**Meeting Between the U.S. Nuclear
Regulatory Commission Staff and the
Nuclear Energy Institute to Discuss
Current License Renewal Topics**

September 15, 2016

Change in J-R Curves with Different Time at Temperature for CF8M with 23% Ferrite

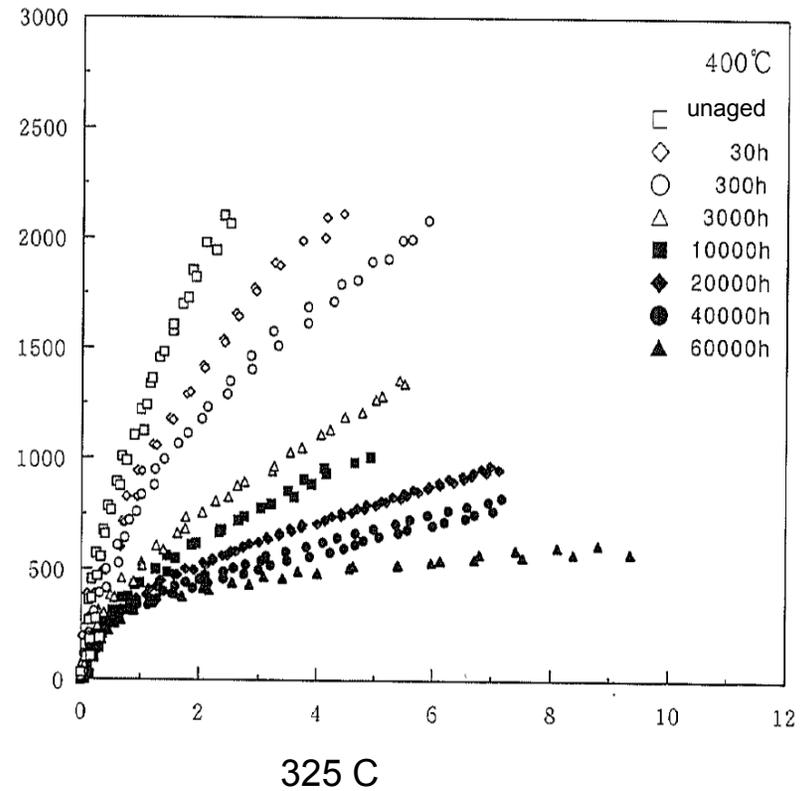
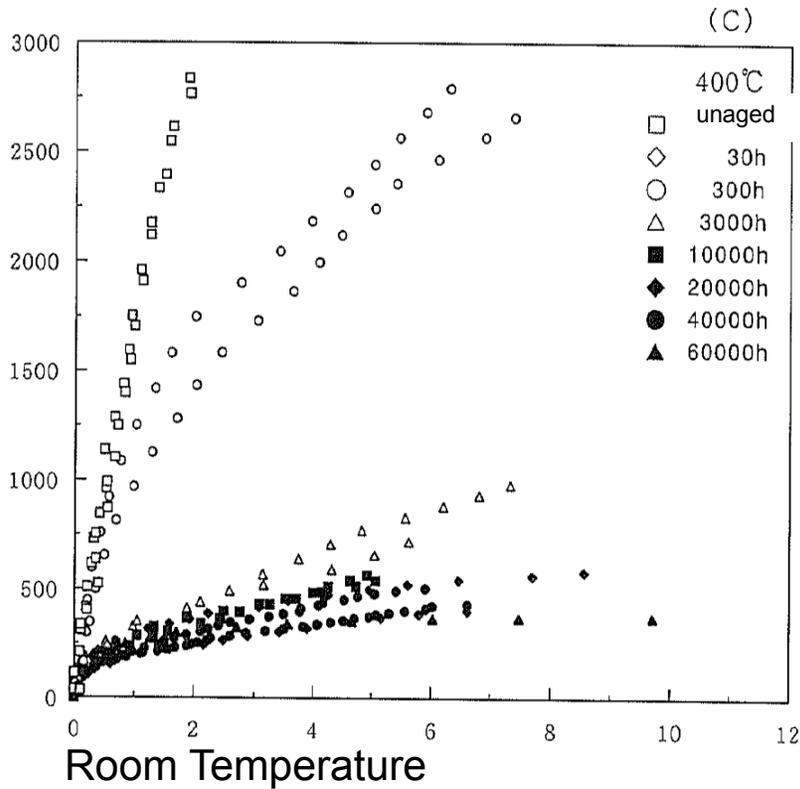
- Although the flaw tolerance evaluation was dropped by ASME Code, it was part of NRC's basis for exempting pump casings in AMP XI.M12.
- Industry provided some information on flaw tolerance evaluations, but the information is only applicable to Westinghouse-design PWRs.
- Industry has not comprehensively demonstrated that all pump casing flaw tolerance evaluations would remain applicable for 80 years.
 - Main issue is whether "saturated" properties for 40 years are really saturated for 80 years.
 - Do generic or plant-specific flaw tolerance evaluations for other vendors (CE, B&W) have similar results and large margins?
- Some pump casings are high molybdenum and ferrite 14% or greater CASS thus TE could be significant, would not meet screening criteria
- ASME Code requirements alone are not always considered sufficient for aging management.

- NRC proposed modification is:
 - For pump casings, as an alternative to the screening and other actions [recommended by AMP XI.M12], no further actions are needed if applicants demonstrate that the original flaw tolerance evaluation performed as part of Code Case N-481 implementation remains bounding and applicable for the SLR period, or this evaluation is revised to be applicable to 80 years.
- In lieu of the above, applicants may choose to perform the screening process for significance of thermal aging embrittlement.
